SUBJECT: OLD CASTLE ROAD PIPELINE PH. 2 PROJECT
[PROJECT NO. 01-06-78-51420]
ADDENDUM NO. 1

ADDENDUM NO. 1
TO CONTRACT DOCUMENTS AND SPECIFICATIONS
FOR CONSTRUCTION OF THE
OLD CASTLE ROAD PIPELINE PH. 2 PROJECT
[PROJECT NO. 01-06-78-51420]

VALLEY CENTER MUNICIPAL WATER DISTRICT
VALLEY CENTER, CALIFORNIA

C-7

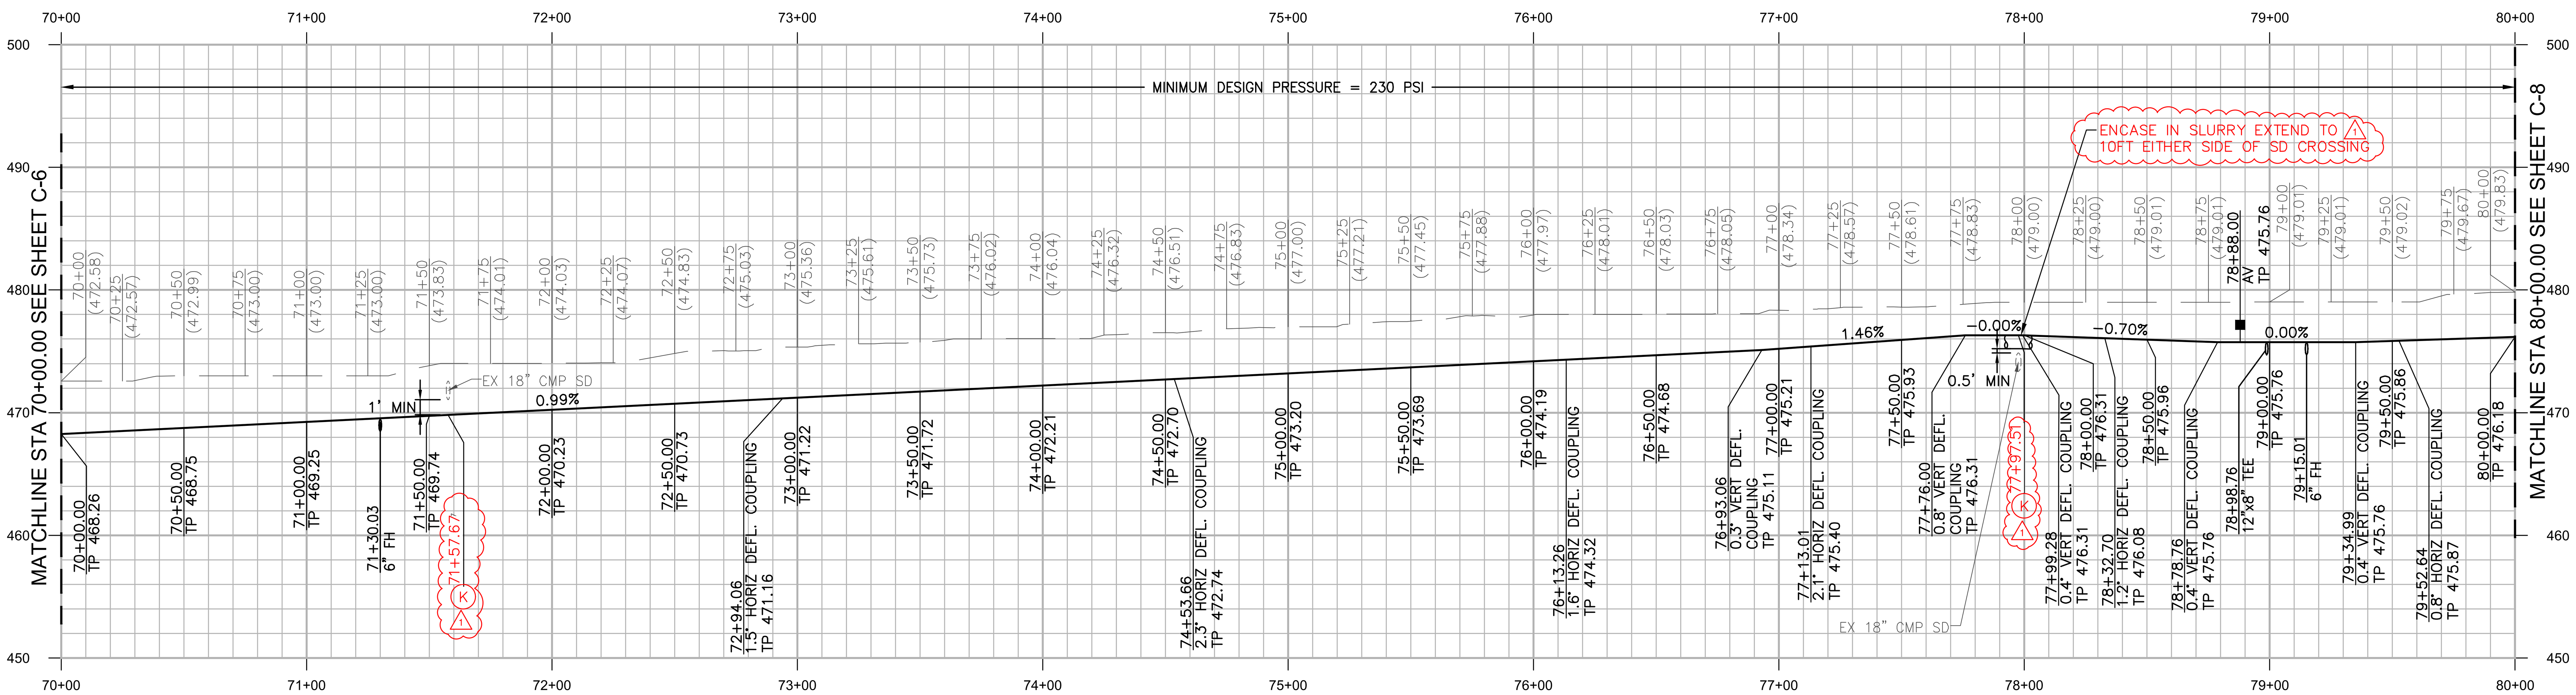
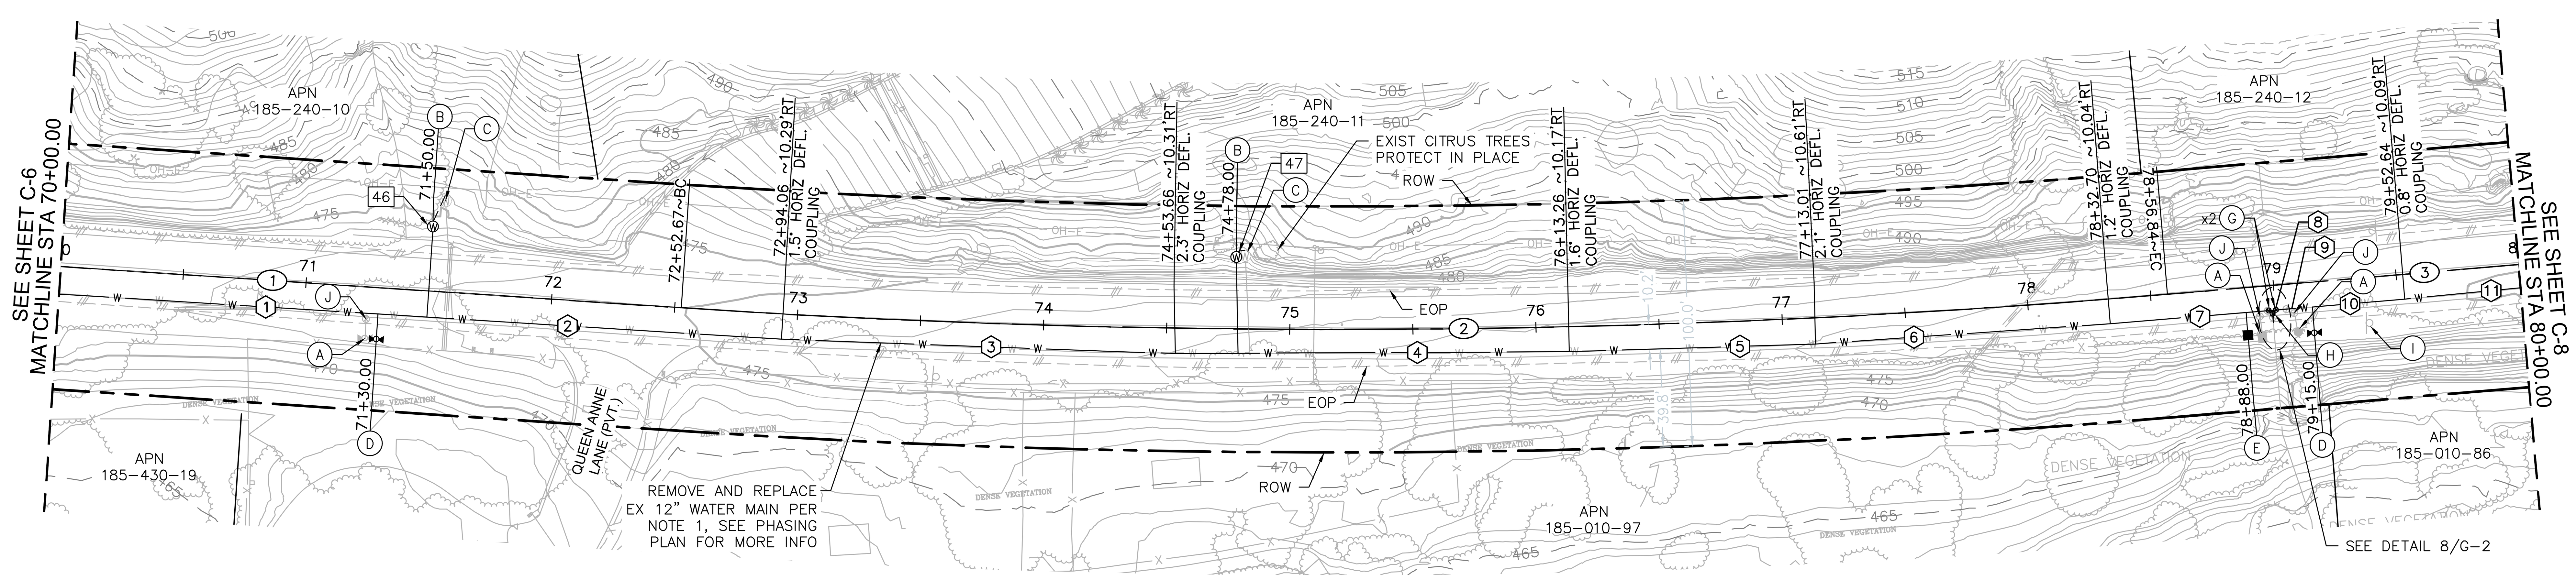
Item No. 8 - Sheet 10 of 34 (C-7)

- Requires a full 20-foot stick of C900 centered at the storm drain crossing.

OLD CASTLE ROAD PIPELINE- PH 2
PLAN AND PROFILE
80+00.00 TO 90+00.00

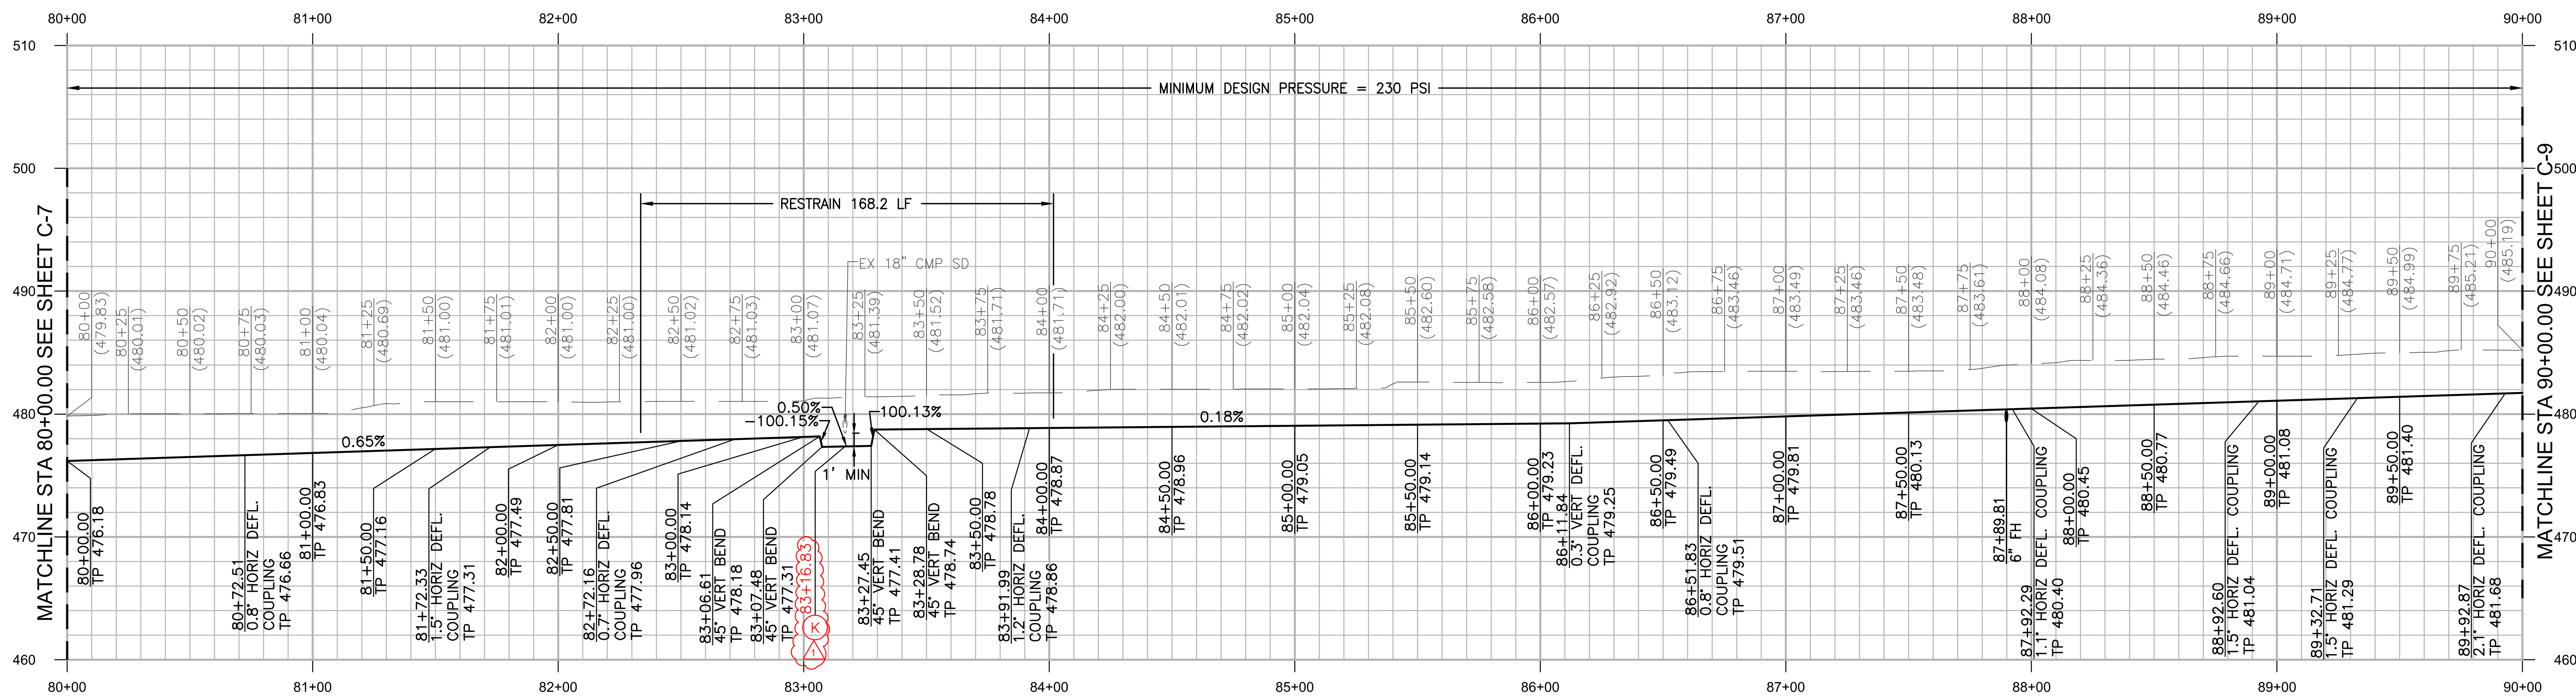
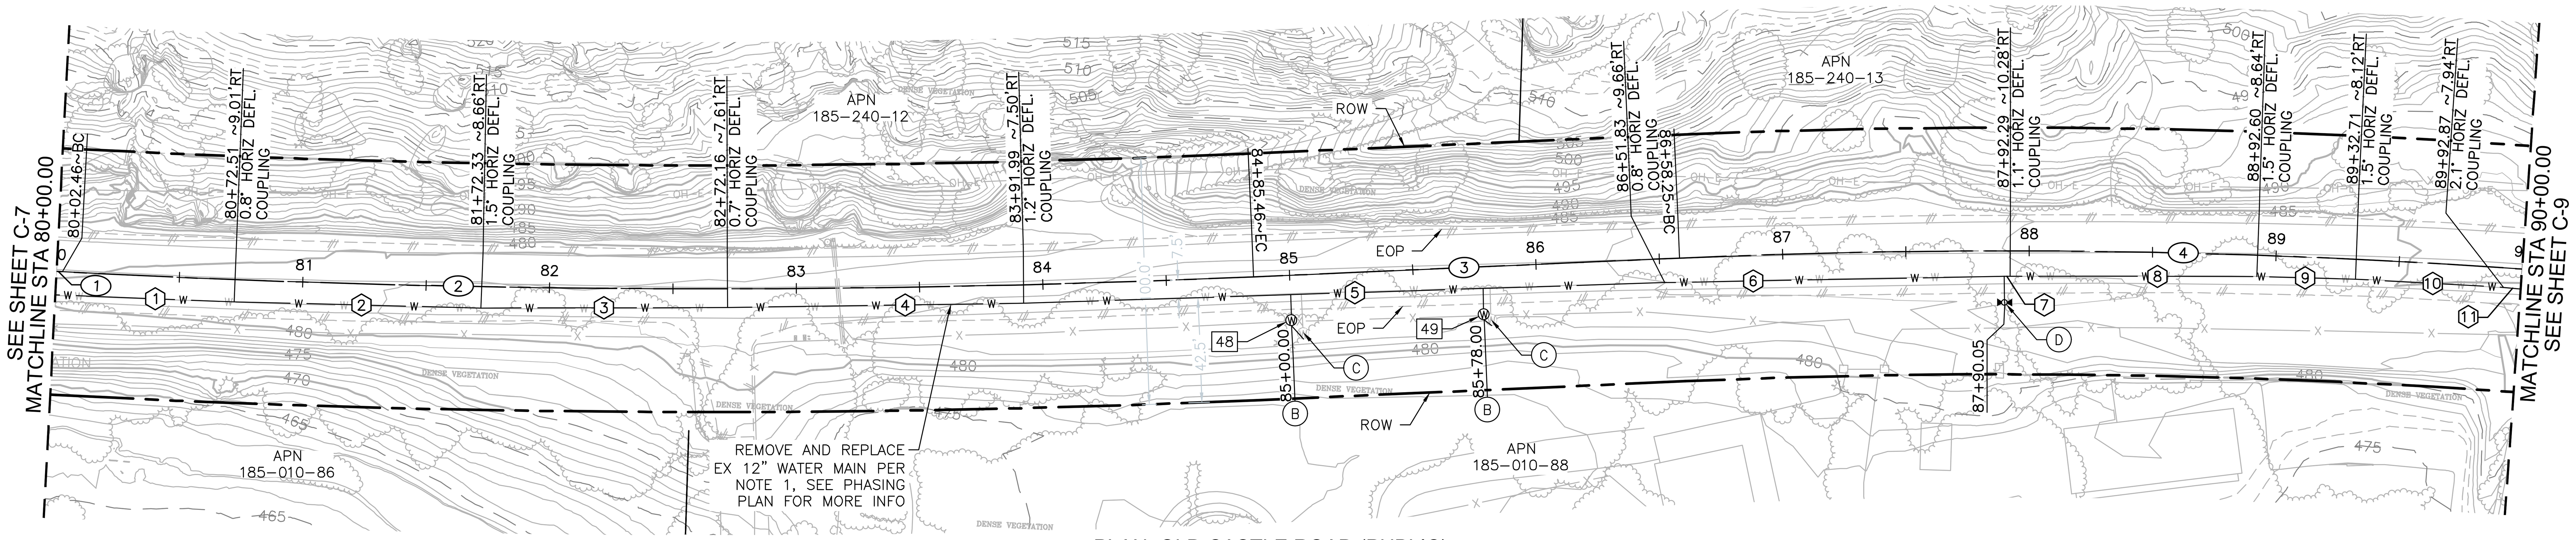
Item No. 9 - Sheet 11 of 34 (C-8)

- Requires a full 20-foot stick of C900 centered at the storm drain crossing.

OLD CASTLE ROAD PIPELINE- PH 2
PLAN AND PROFILE
90+00.00 TO 100+00.00

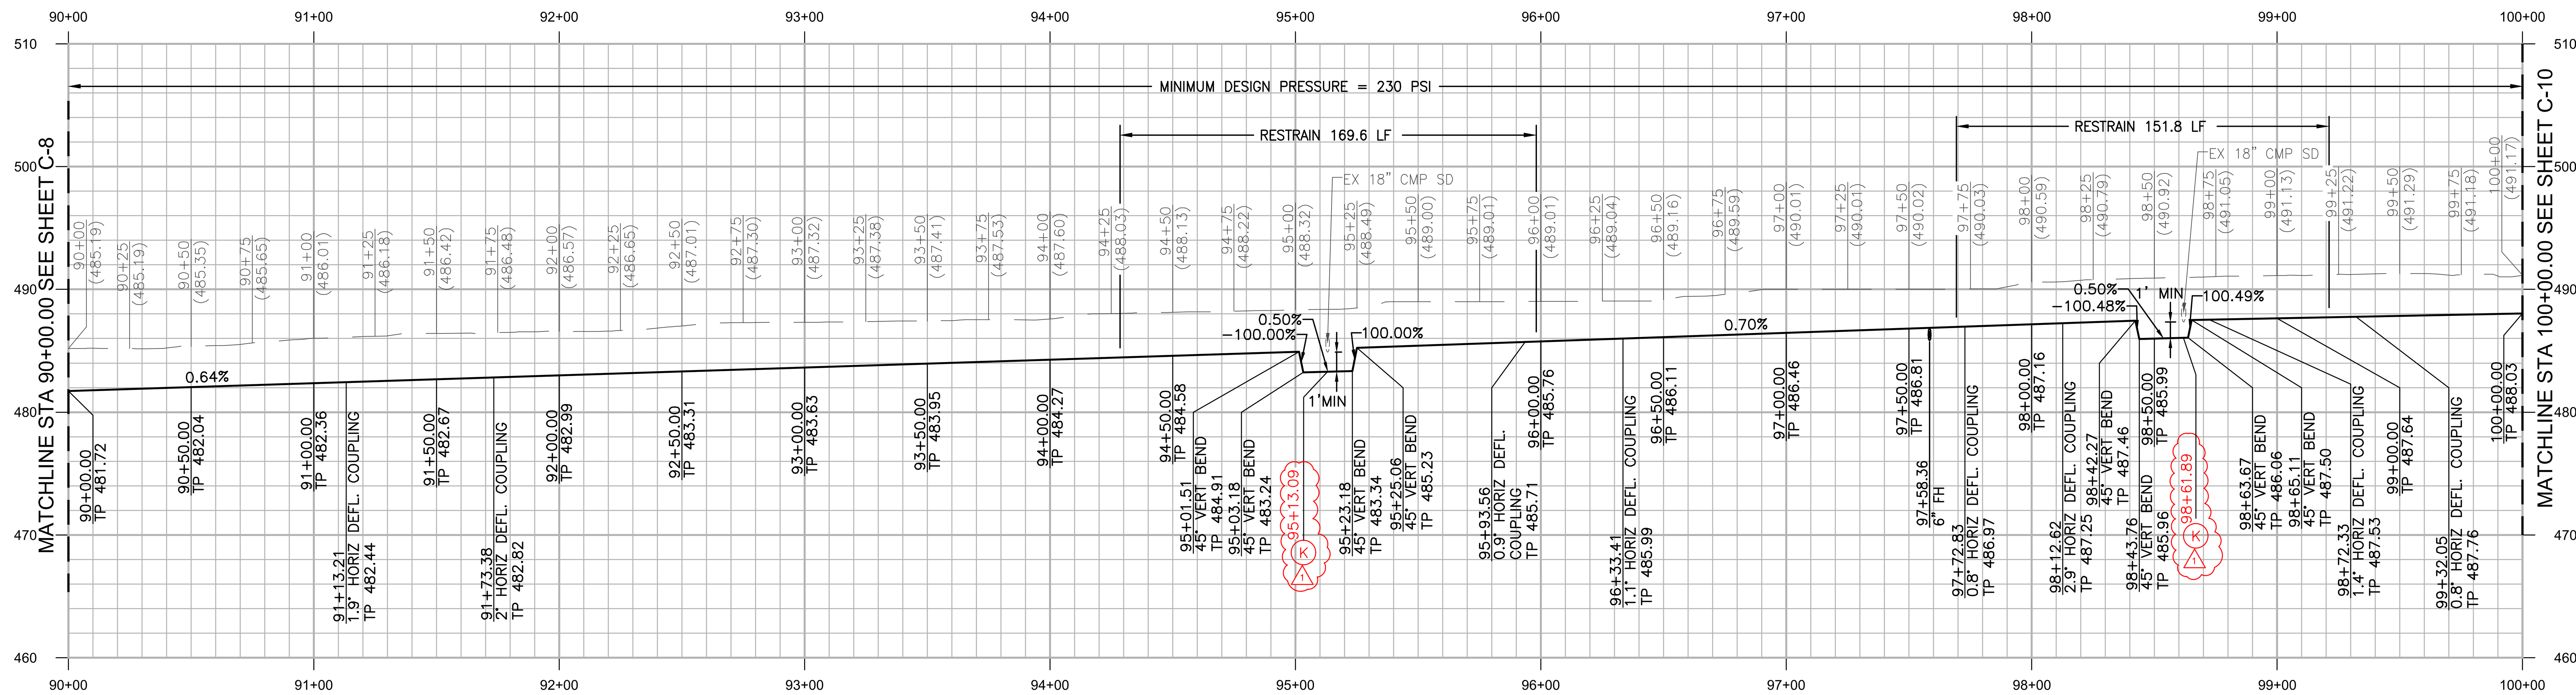
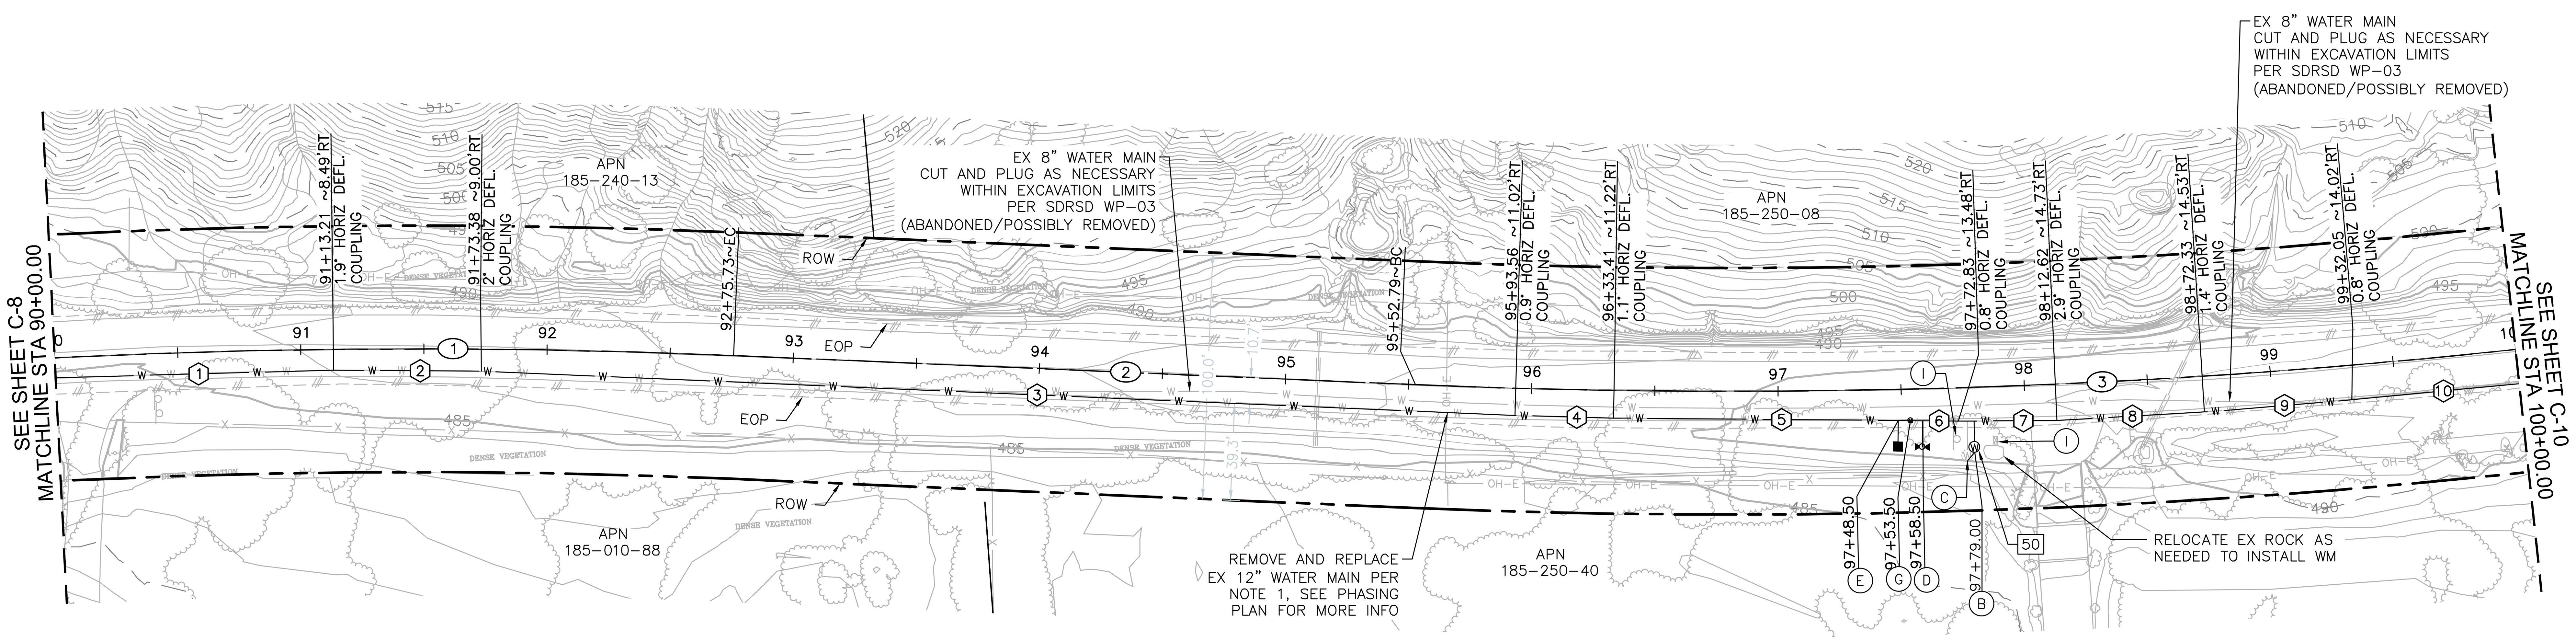
Item No. 10 - Sheet 12 of 34 (C-9)

- Requires a full 20-foot stick of C900 centered at the storm drain crossing.
